The Heath & Hampstead Society

Planning Ref: 2019/5141/P

Address: 33 Willow Cottages NW3 1TN

Date: 4th May 2020

Figure 16 actually centred over 13 Gayton Cresc

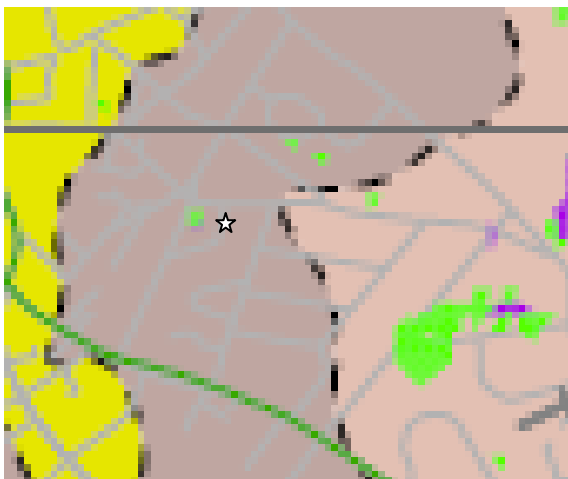
It is clear that parts of the BIA are actually inaccurate. The red circle defining the position of 33 Willow Cottages on Arup's 'Camden Geological, Hydrogeological and Hydrological Study: Slope Angle Map' Figure 16 for example is actually centred over 13 Gayton Crescent, and on Arup's Figure 12 over 12 Pilgrims Lane! It doesn't help that poorly reproduced maps are given.

British Geological Survey 1 : 50 000 series North London Sheet 256 Bedrock and Superficial Deposits

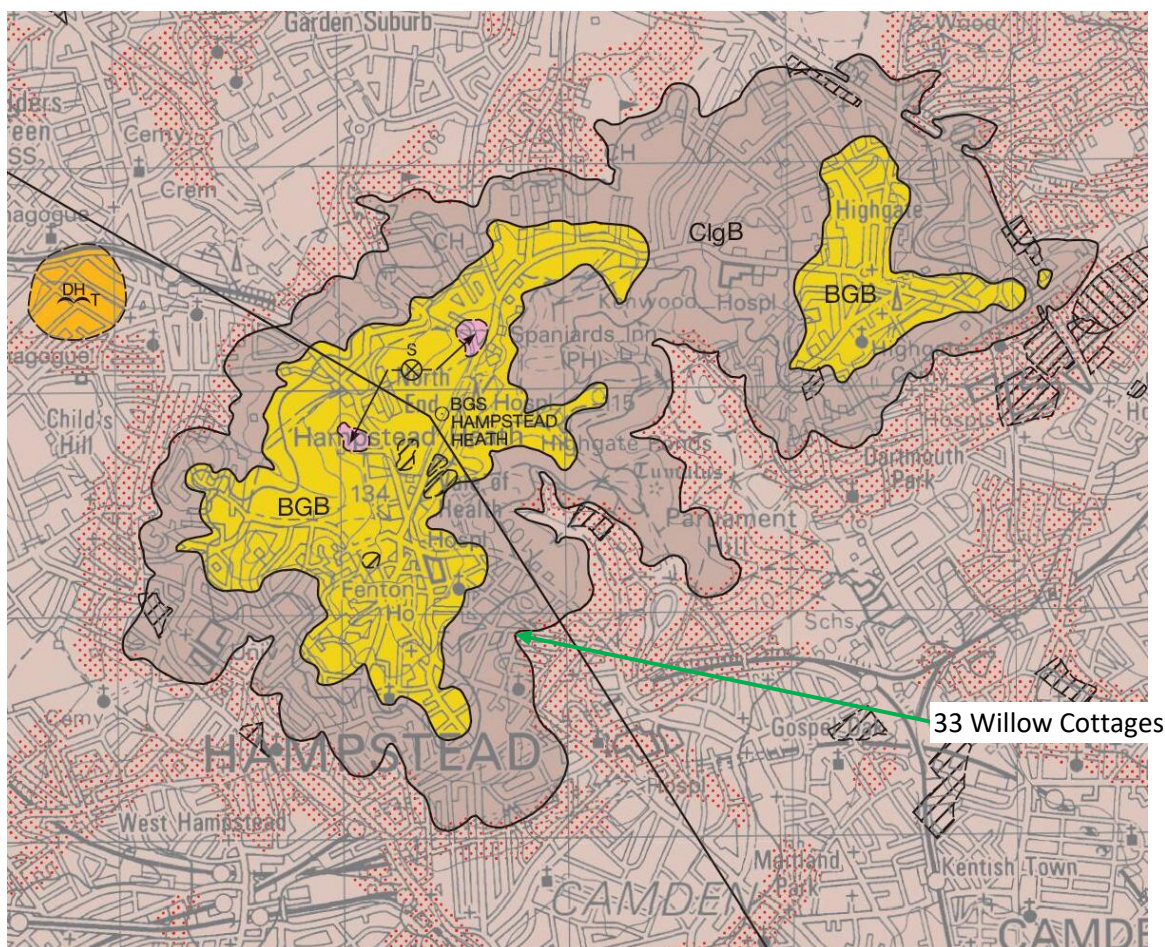
3.2.5 Slope Stability states that '...the site area is outwith the "Areas of significant Landslide potential" defined by the BGS on map sheet 256 and included in the ARUP report as Figure 17.'

This is NOT TRUE. It is right over an area of High/Very High risk for slope instability - see British Geological Survey Areas for Greatest Potential for Slope Instability <http://www.largeimages.bgs.ac.uk/iip/mapsportal.html?id=1001750> (and see over) based on Forster A, Wildman G & Poulton C. (2003) Landslide potential modelling of North London. British Geological Survey Internal Report, IR/03/122R.

British Geological Survey Areas for Greatest Potential for Slope Instability

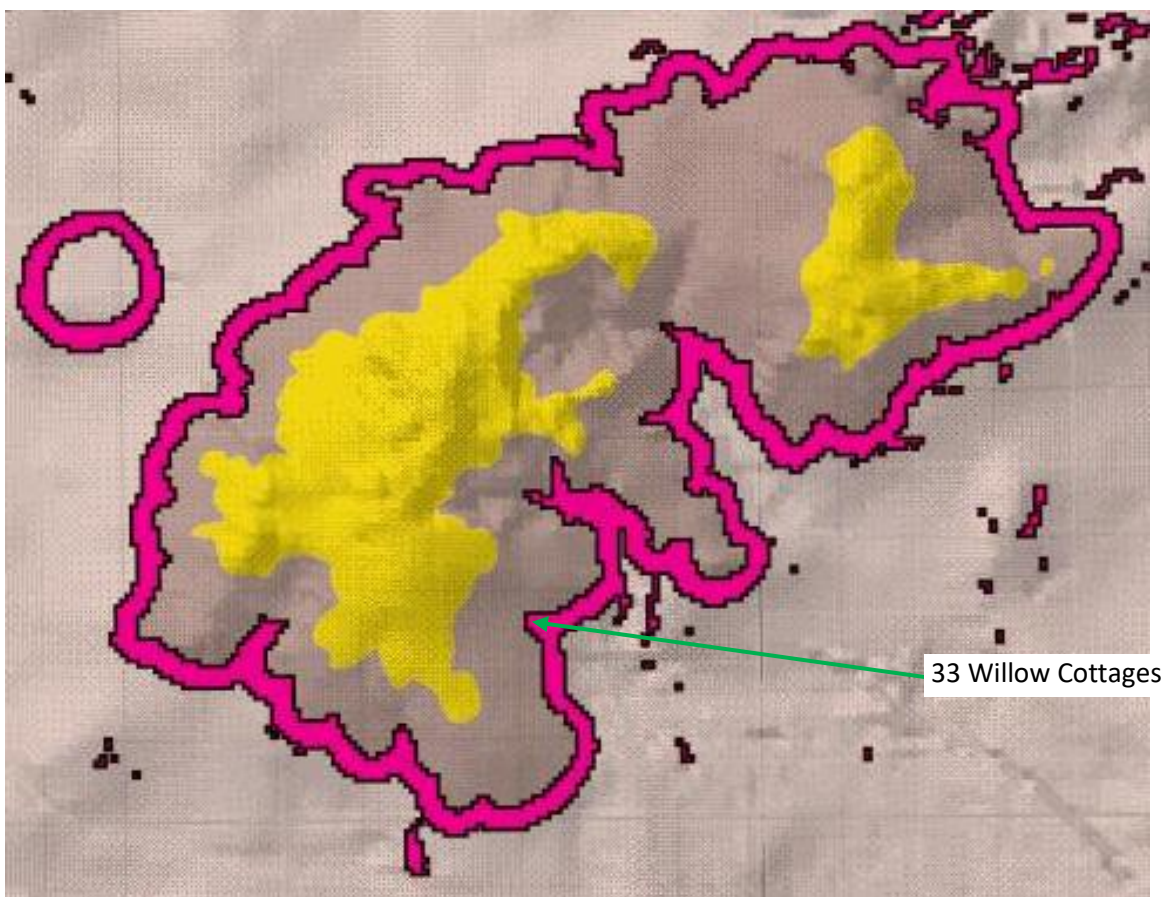
It is interesting that despite reference to it, Arup's Figure 17 is not shown at all, with or without an inaccurate red circle. In fact this shows that 33 Willow Cottages are right bang on this area:
